Nine Mile Point  
Nuclear Station

**SUBJECT:** Nine Mile Point Unit 2  
Docket No. 50-410  
Facility Operating License No. NPF-69

License Amendment Request: Revised Safety Limit Minimum Critical Power  
Ratio in Technical Specification 2.1.1.2

Figure 1 Reference Core Loading Pattern – Cycle 10

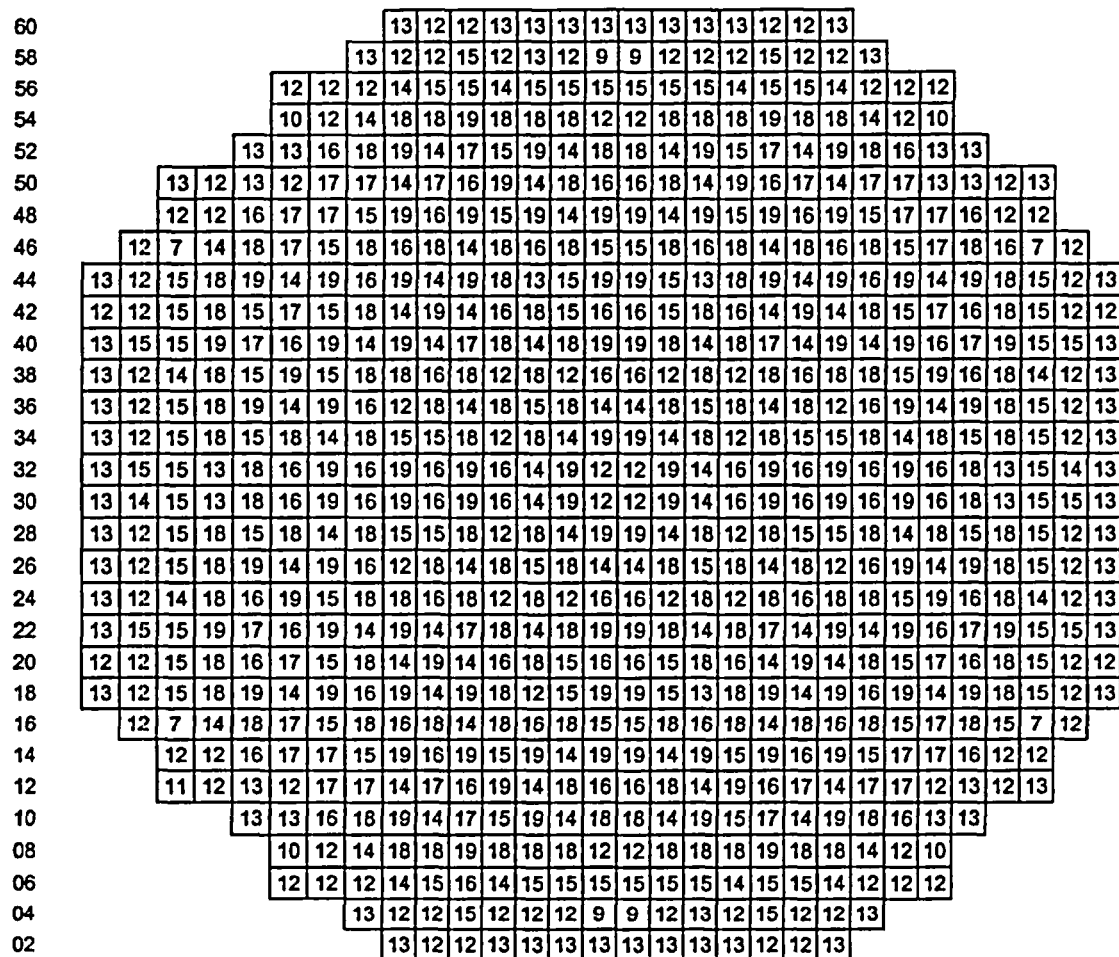
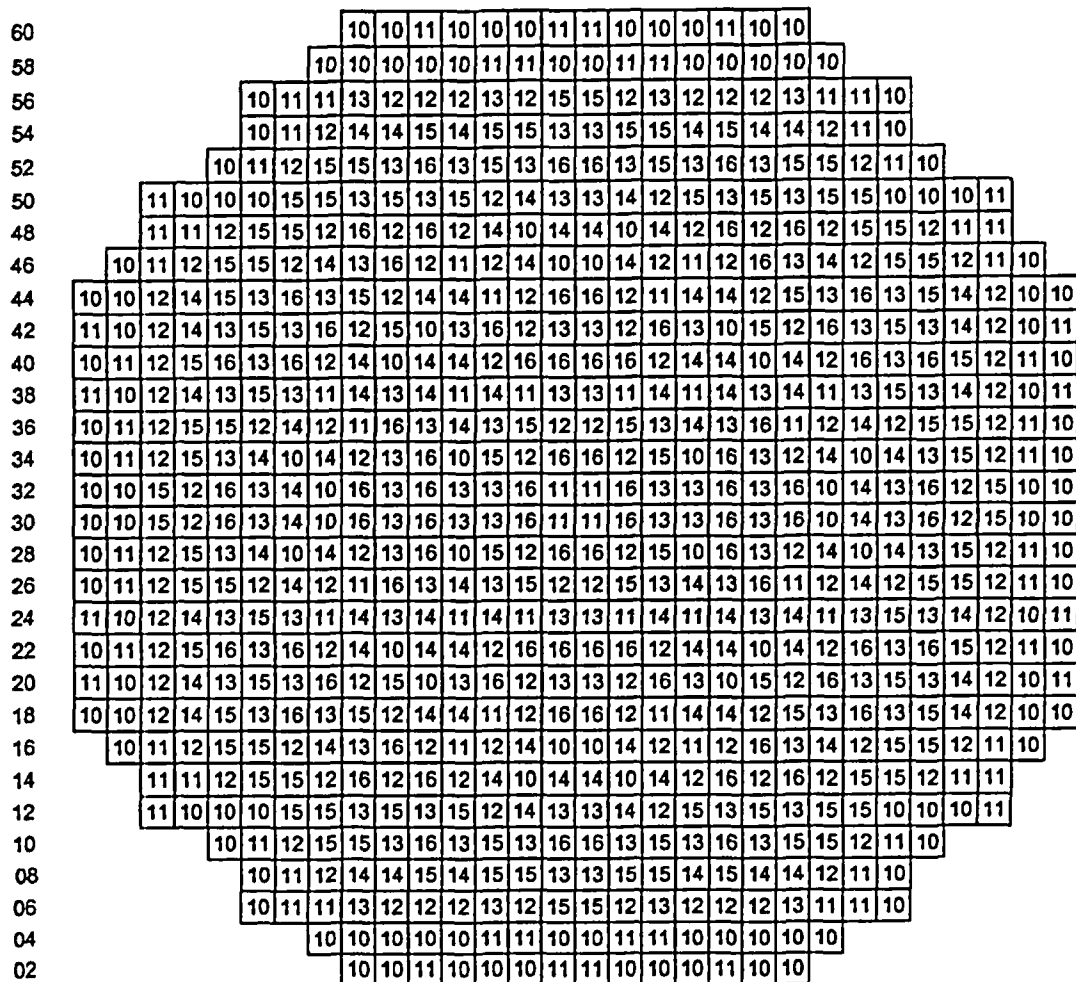
The core loading information for Nine Mile Point Unit 2 Cycle 10 is provided in Figure 1. For comparison the core loading information for Nine Mile Point Unit 2 Cycle 9 is provided in Figure 2. The impact of the fuel loading pattern differences on the calculated SLMCPR is correlated to the values of [[
